STANDARD PRACTICES - ENGINE - INFORMATION - ENGINE - FUEL AND CONTROL - TO ANNOUNCE THE  
AVAILABILITY OF A FUEL DIVERTER AND RETURN VALVE WITH CHROME PLATING ON THE PISTON ROD  
- CATEGORY CODE 8 - MOD.ENG-70-0308

V2500-ENG-70-0308

No. 17300-73-002

## ENGINE FUEL CONTROL - INTRODUCTION OF A NEW FUEL DIVERTER AND RETURN VALVE

Location of the Rod (Old and New Part Configuration)  
Figure 1

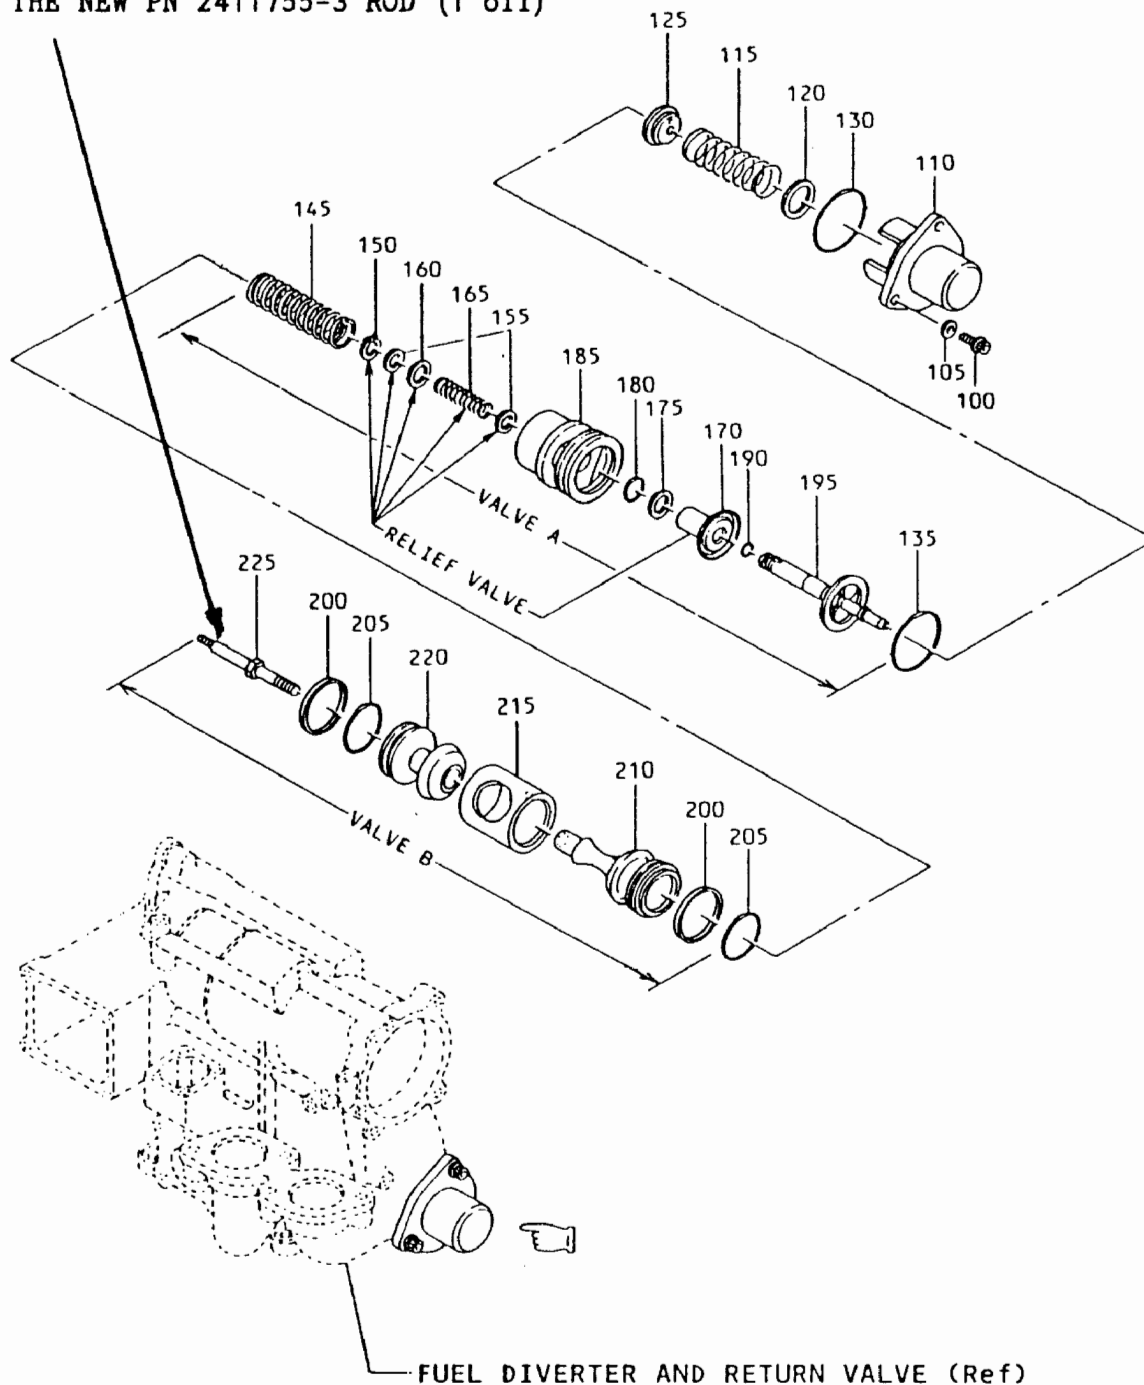
- (1) The existing rod have been changed to chrome plated rod. (See Figure 1)
- (2) The existing FDRV can be reworked and reidentified to a new configuration from the existing 2411755, FDRV to a new 2411755-3, FDRV.
- (3) This Service Bulletin provides accomplishment instructions for reworking the rod, and also provides instruction for the reidentification of FDRV.
- (4) This Service Bulletin describes three options to accomplish the modification of the FDRV as follows:
  - (a) Option 1 : Operators who wish to have the modification accomplished by IHI.
  - (b) Option 2 : Operators who wish to accomplish the modification in the shop by replacing rod.
  - (c) Option 3 : Operators who wish to accomplish the modification in the shop by reworking the rod.

REPLACE THE EXISTING PN 2411755 ROD (1 off), WITH  
THE NEW PN 2411755-3 ROD (1 off)

Rod - Before and After Alteration  
Figure 2

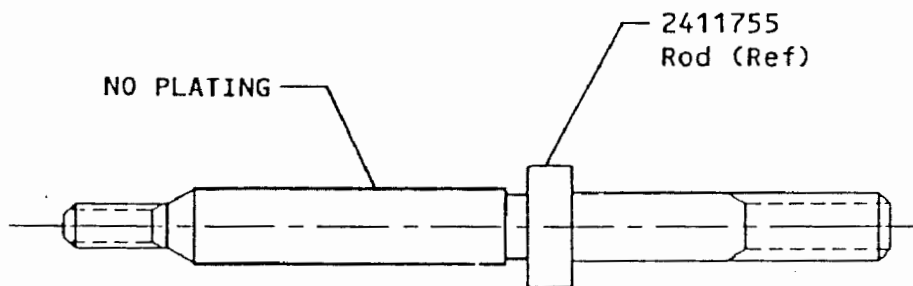
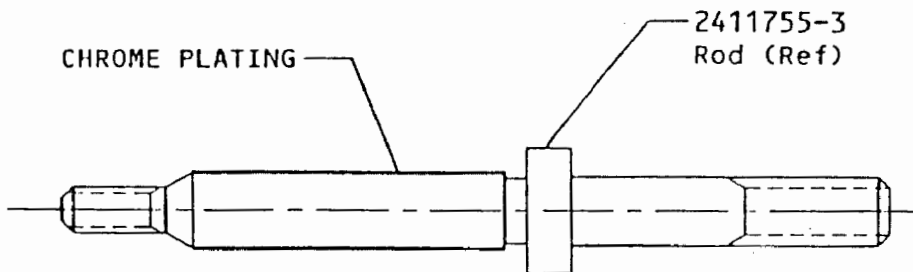
BEFORE ALTERATION

AFTER ALTERATION

Reidentification of Fuel Diverter and Return Valve  
Figure 3

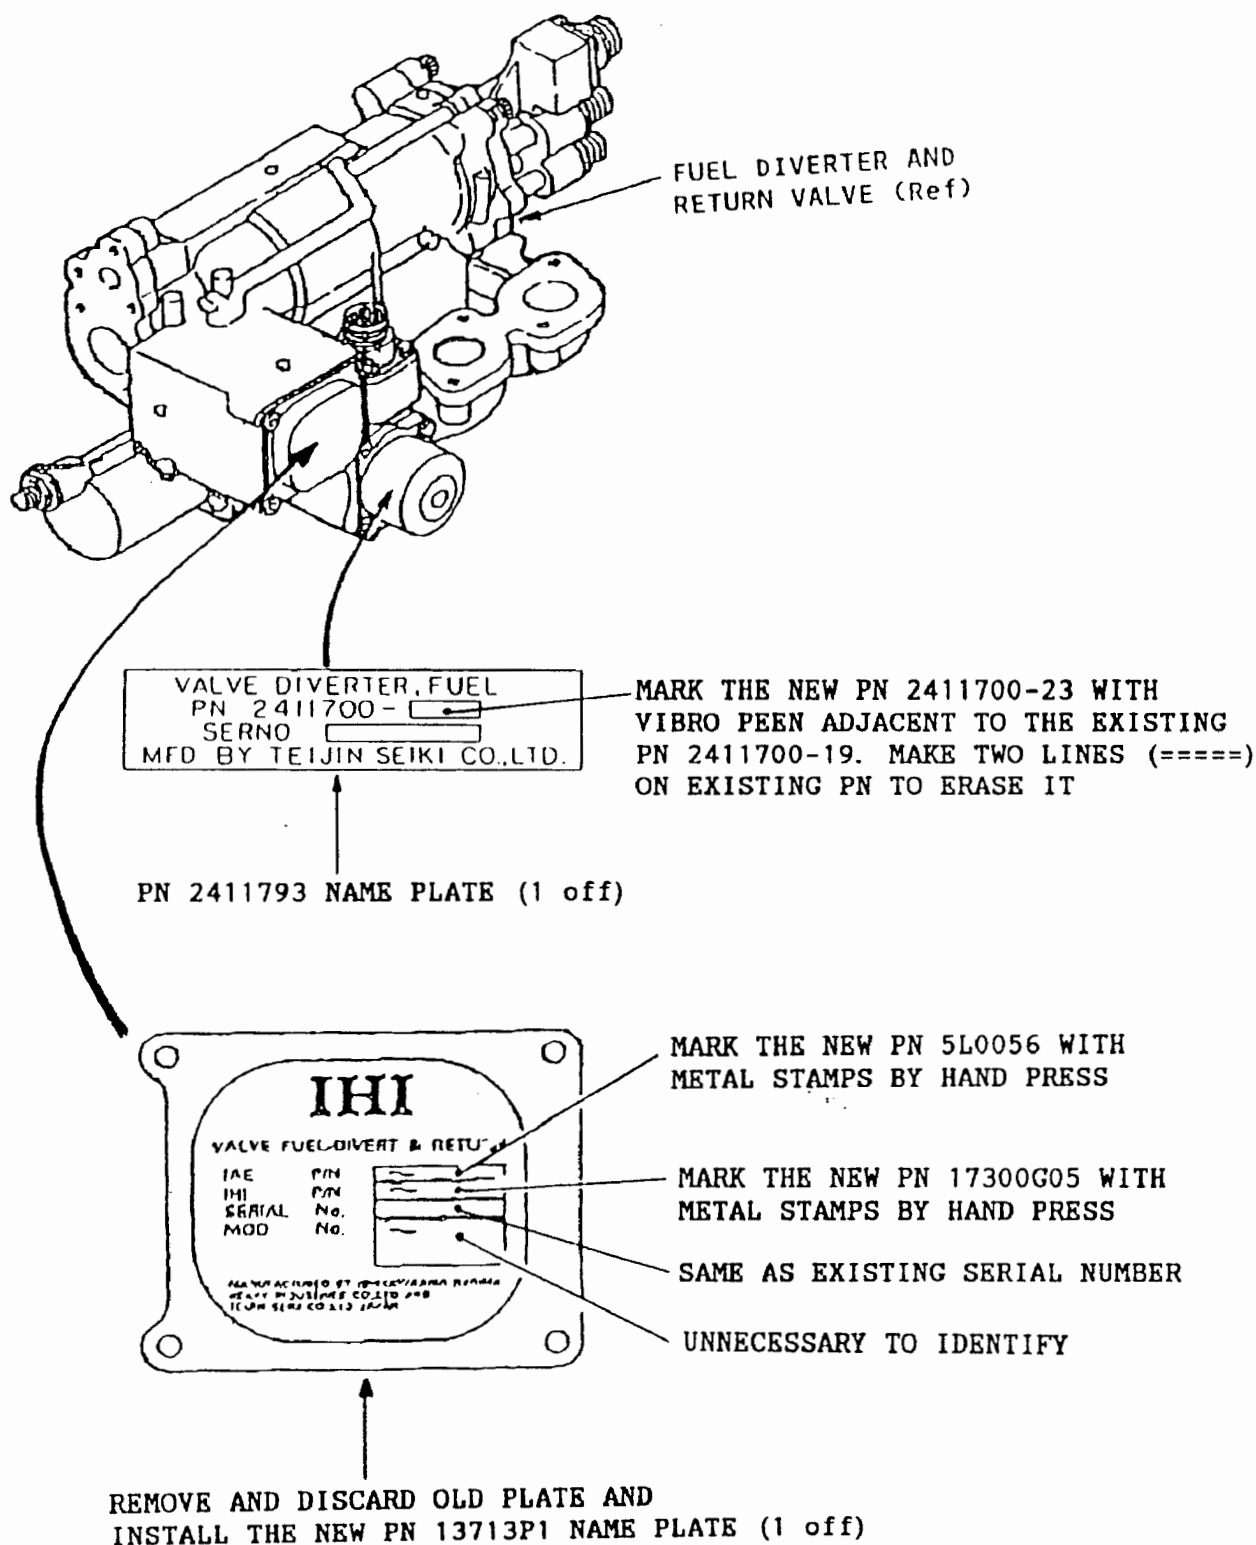
- (d) Mark the new part number on the new 13713P1, name plate and identify as follows:  
Use the metal stamps by hand press (Refer to Figure 3).

- (e) Identify with the new part number adjacent to old part number on the 2411793, existing name plate. Use the vibro peen method (Refer to Figure 3).
- (f) Do a functional testing by the approved procedures in the IHI Component Maintenance Manual, 73-18-52, Testing and Fault Isolation.

IAE	P/N	5L0056
IHI	P/N	17300G05
SERIAL	No.	Same as existing number
MOD	No.	Unnecessary to identified

Rework Instruction of Old Rod  
Figure 4

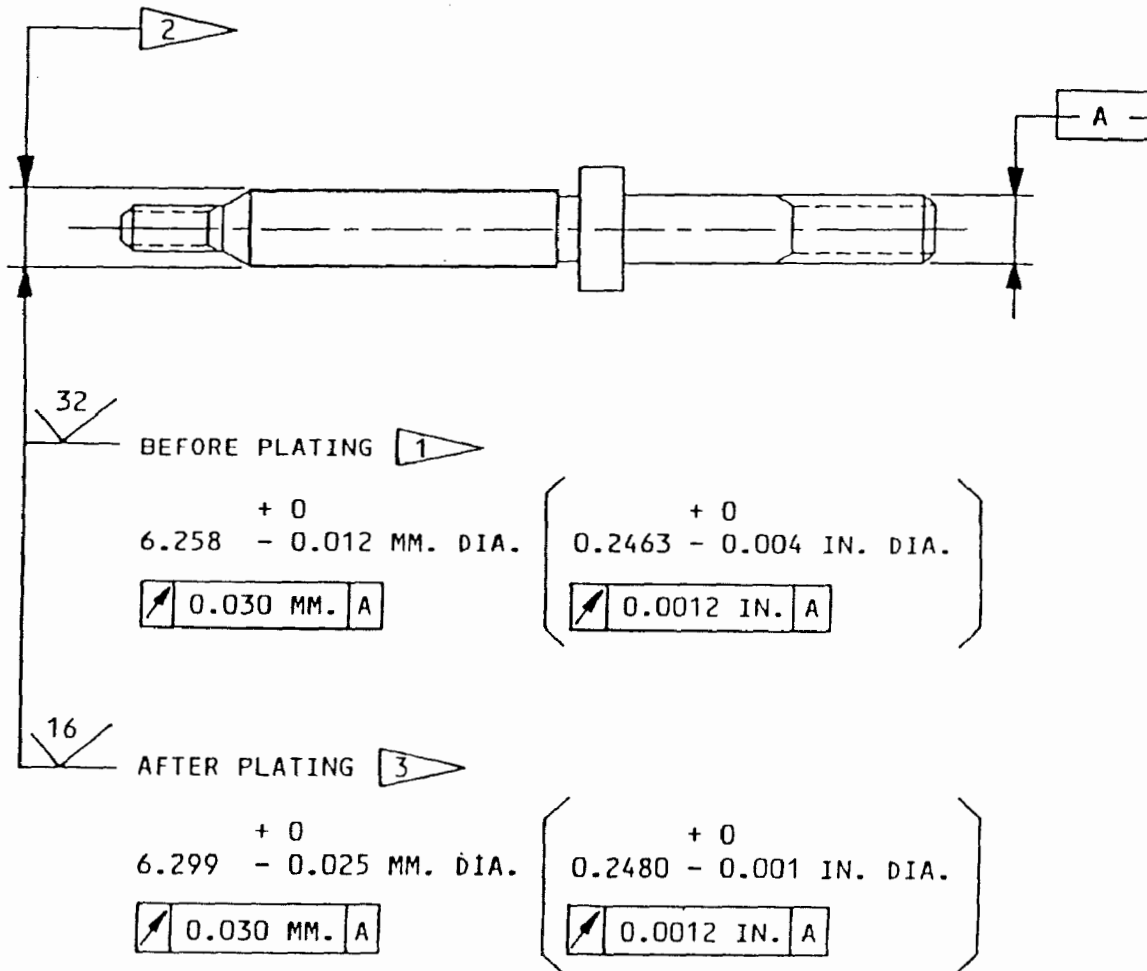
- (b) Rework the 2411755, rod by the approved procedures in accordance with Rework instruction of the rod (Refer to Figure 4).
  - (c) Assemble the FDRV and Installation of the name plate by the approved procedures in accordance with IHI Component Maintenance Manual, 73-18-52, Assembly.

REWORK ROD, PN 2411755 TO NEW ROD, PN 2411755-3.

MATERIAL : 15-5PH PER AMS 5659

HEAT TREAT : MIL-H-6875 COND. H1050.

- 1 BEFORE CHROME PLATING
  - (1) GRIND OUTSIDE DIAMETER.
  - (2) MAGNETIC INSPECTION PER MIL-STD-1949 CLASS 3.
  - (3) PASSIVATE PER MIL-S-5002.
- 2 CHROME PLATING

CHROME PLATE PER QQ-C-320, THICKNESS 0.008 MM. (0.00032 IN.) MINIMUM.
- 3 AFTER CHROME PLATING
  - (1) GRIND OUTSIDE DIAMETER.
  - (2) MAGNETIC INSPECTION PER MIL-STD-1949 CLASS 3.
